Form 3160-5
(June 2019)UNITED STATES
DEPARTMENT OF THE INTERIOR
BUREAU OF LAND MANAGEMENTFORM APPROVED
OMB No. 1004-0137
Expires: October 31, 2021**SUNDRY NOTICES AND REPORTS ON WELLS**
Do not use this form for proposals to drill or to re-enter an abandoned well. Use Form 3160-3 (APD) for such proposals.

8. Well Name and No. LACEY SWISS 1 FED COM/710H

EOG respectfully requests an amendment to our approved APD for this well to reflect the following changes:

Revised Permit Information 04/26/2022:

WELL LOCATION AND ACREAGE DEDICATION PLAT

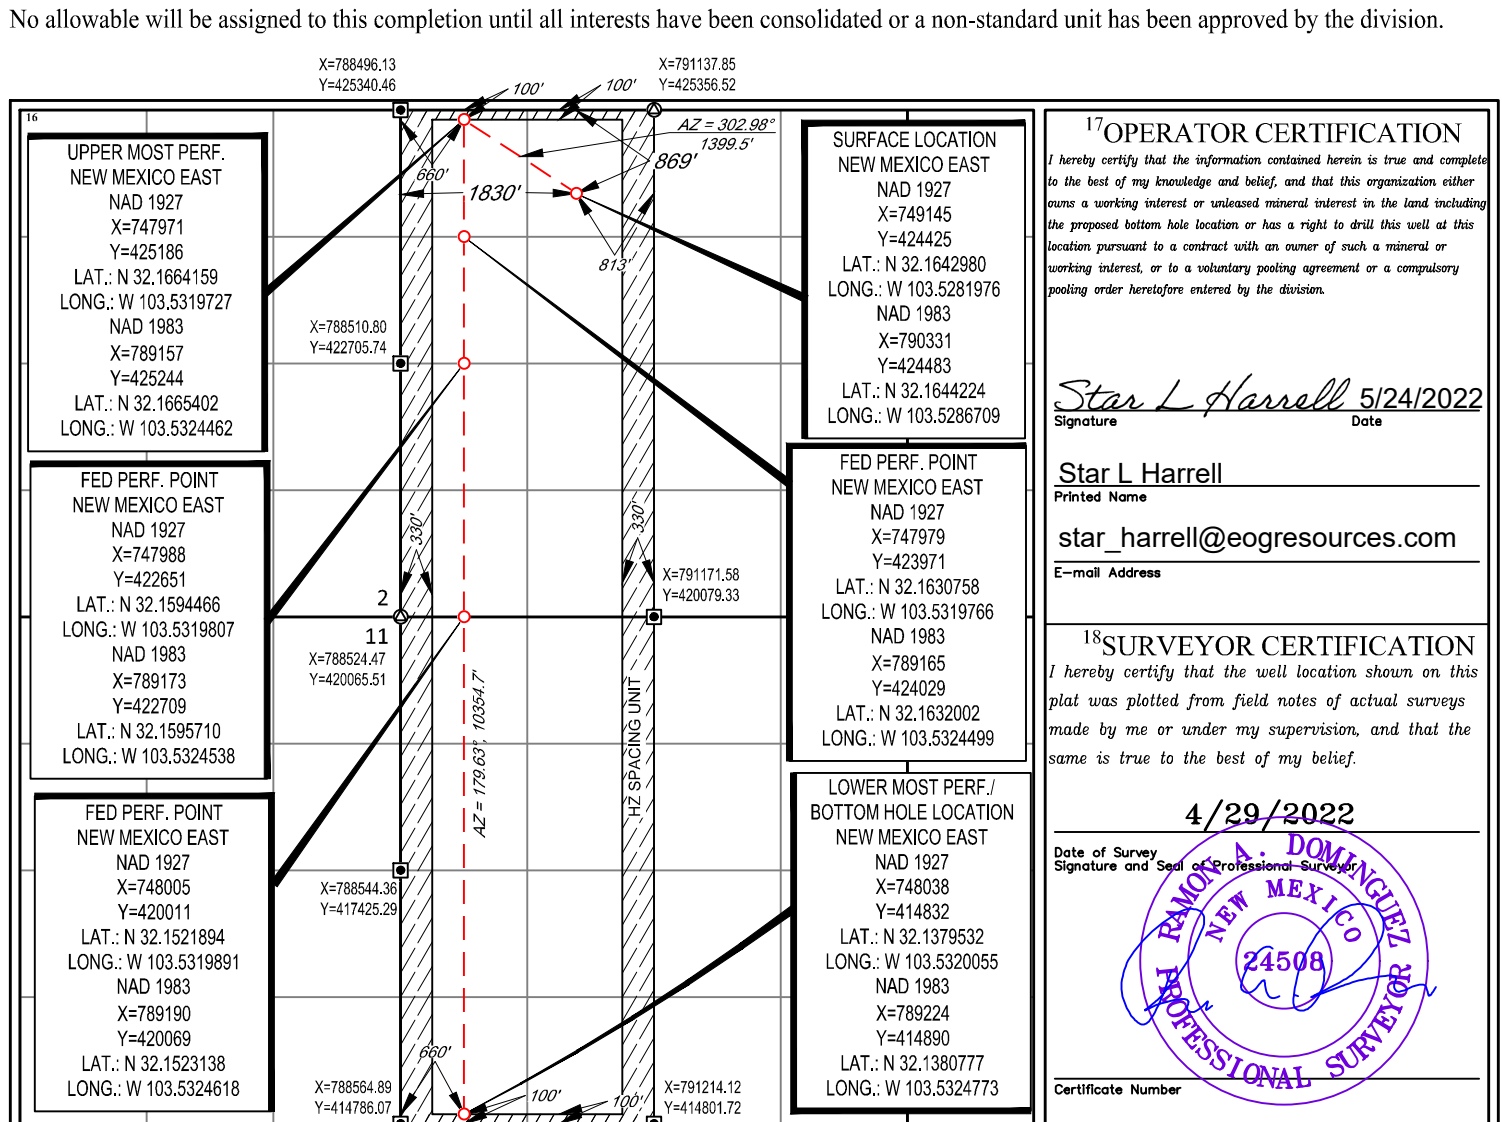
Change name from 710H to Lacey Swiss 1 Fed Com 726H.

Change SHL from T-25-S, R-33-E, Sec 1, 216' FNL, 355' FWL, Lea Co., NM, to T-25-S, R-33-E, Sec 1, 869' FNL, 1830' FWL, Lea Co., N.M.

Change BHL from T-25-S, R-33-E, Sec 12, 100' FSL, 330' FWL, Lea Co., NM, to T-25-S, R-33-E, Sec 12, 100' FSL, 660' FWL, Lea Co., N.M.

¹⁰Surface Location

UL or lot no.	Section	Township	Range	Lot Idn	Feet from the	North/South line	Feet from the	East/West line	County
3	1	25-S	33-E	-	869'	NORTH	1830'	WEST	LEA

¹¹Bottom Hole Location If Different From Surface

UL or lot no.	Section	Township	Range	Lot Idn	Feet from the	North/South line	Feet from the	East/West line	County
M	12	25-S	33-E	-	100'	SOUTH	660'	WEST	LEA

Revised Wellbore

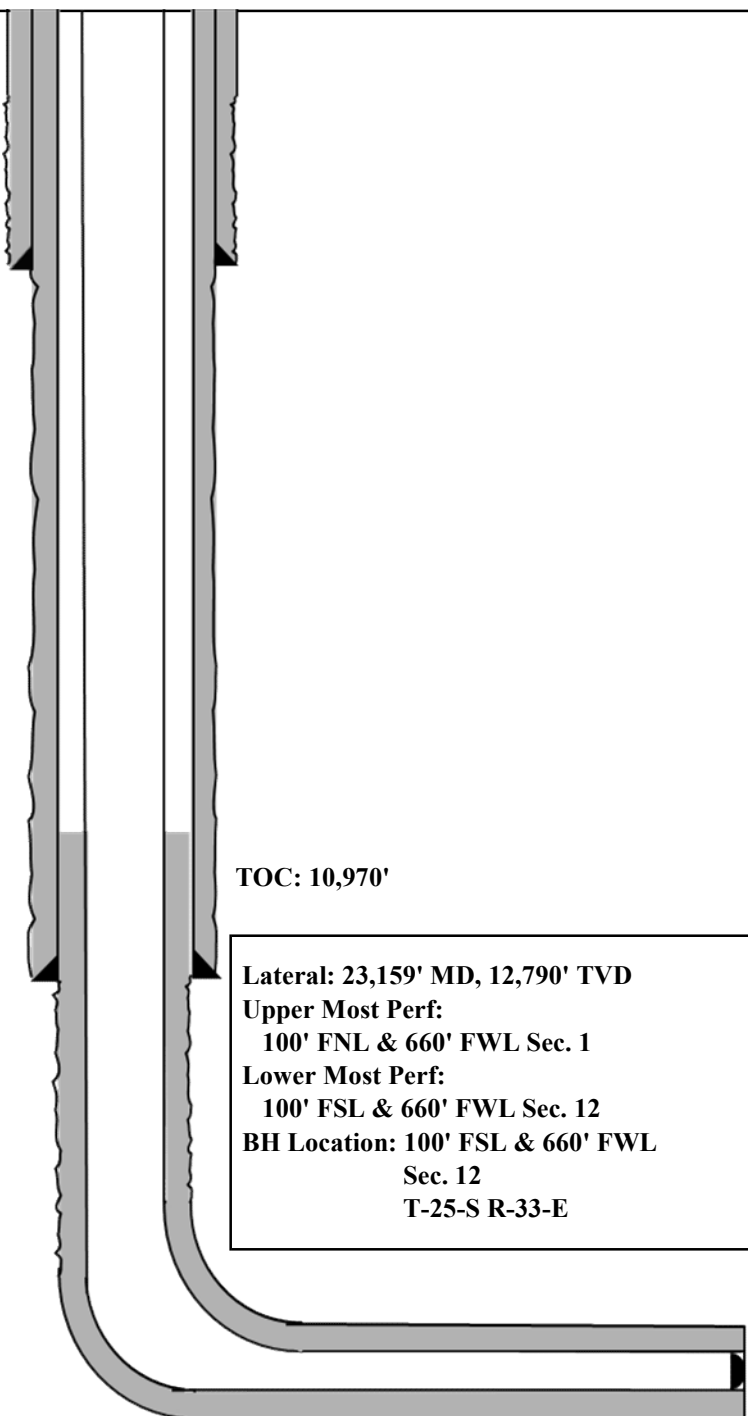
Update casing and cement program to current design.

Bit Size: 12-1/4"
9-5/8", 36#, J-55, LTC,
@ 0' - 1,300'

Bit Size: 8-3/4"
7-5/8", 29.7#, HCP-110, FXL,
@ 0' - 11,470'

Bit Size: 6-3/4"
5-1/2", 20#, P110-EC, DWC/C IS MS,
@ 0' - 10,970'
5-1/2", 20#, P110-EC, Vam Sprint SF,
@ 10,970' - 11,470'
5-1/2", 20#, P110-EC, DWC/C IS MS,
@ 11,470' - 23,159'

KOP: 12,482' MD, 12,312' TVD
EOC: 13,232' MD, 12,790' TVD

Figure 1: Cameron TA Plug and Offline Adapter Schematic

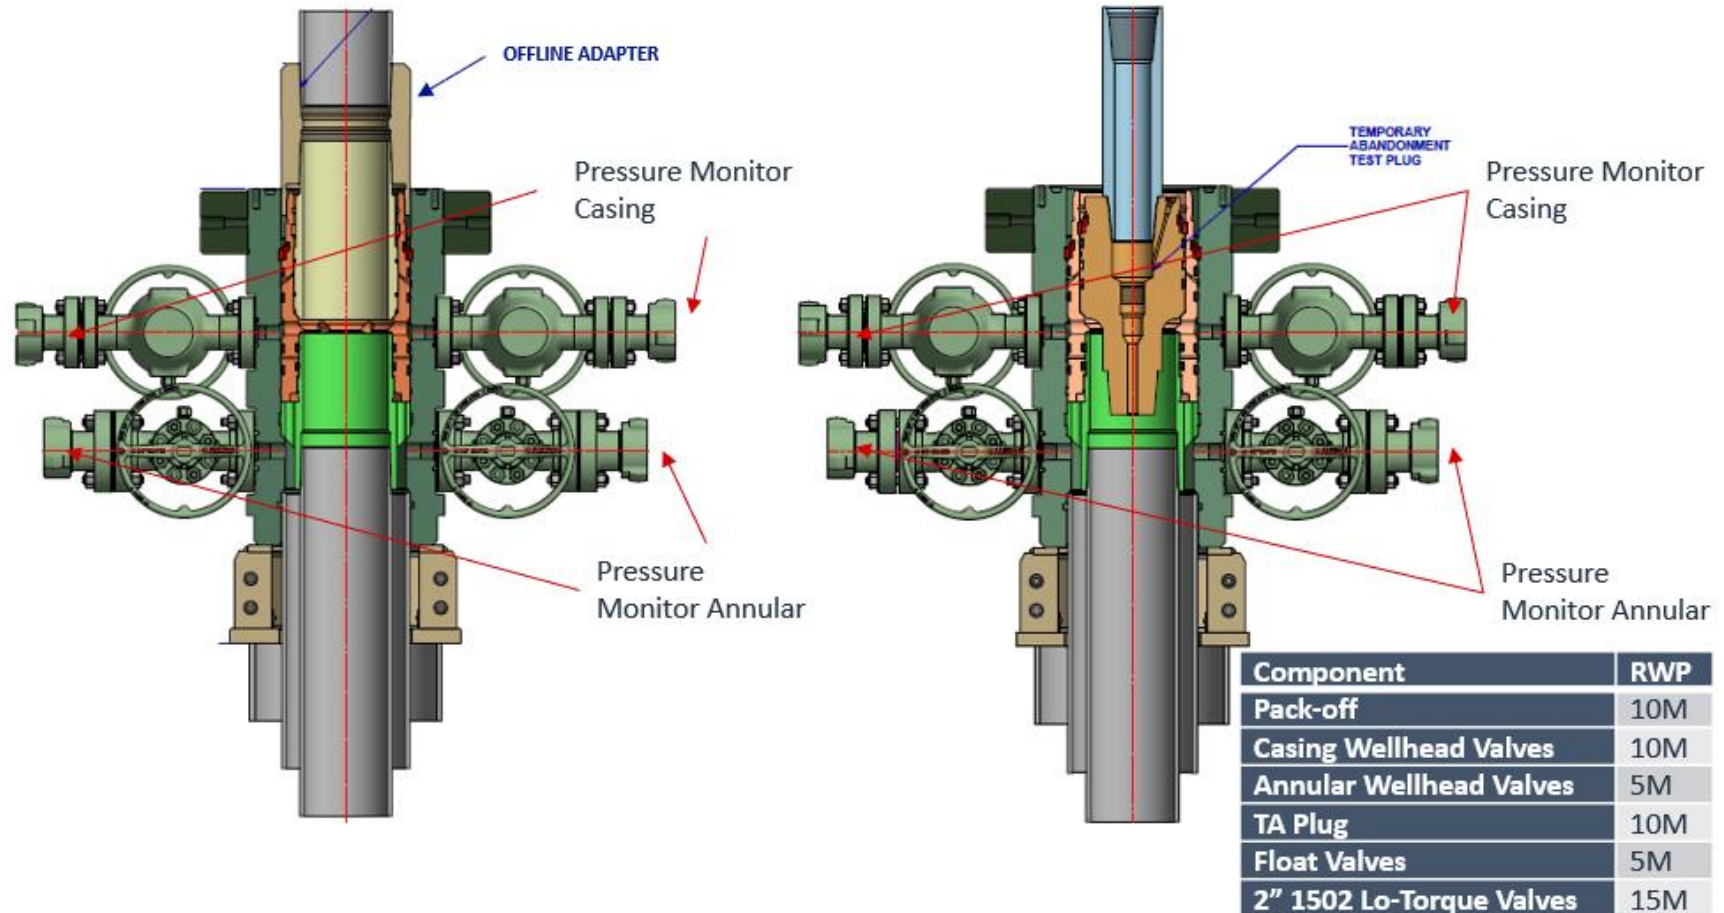
- c. Return line schematics can be seen in Figure 3.
10. Remove TA Plug from the casing.
11. Install offline cement tool.
 - a. Current offline cement tool schematics can be seen in Figure 1 (Cameron) and Figure 2 (Cactus).

Figure 4: Rig Placement Diagram

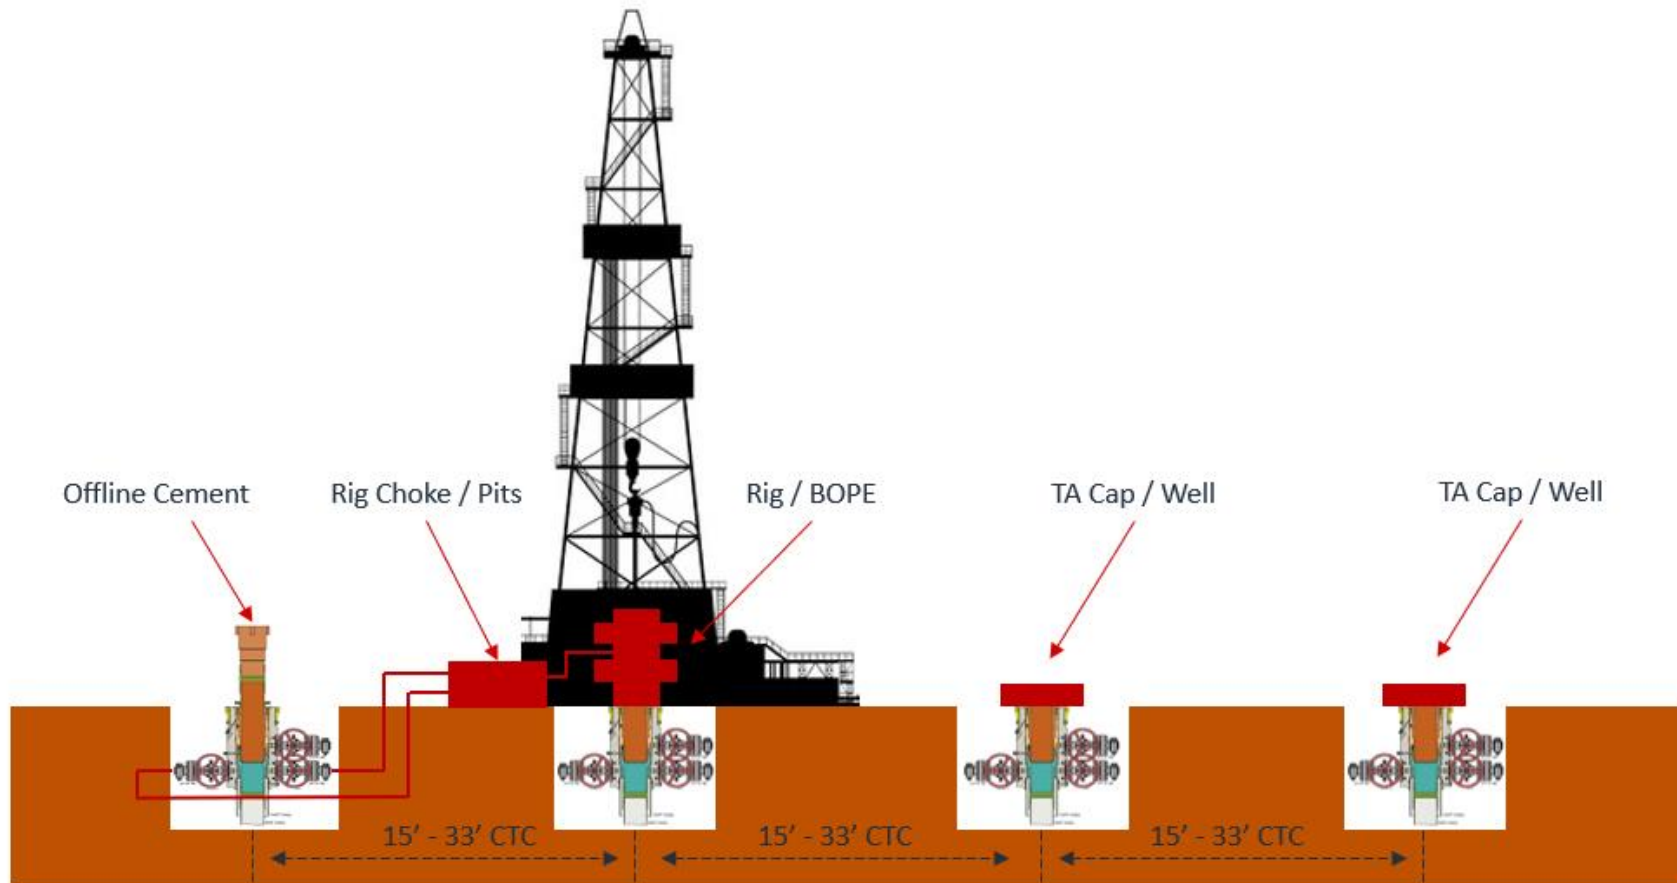
- e. Diagram for rig positioning relative to offline cementing can be seen in Figure 4.
9. Rig up return lines to take returns from wellhead to pits and rig choke.
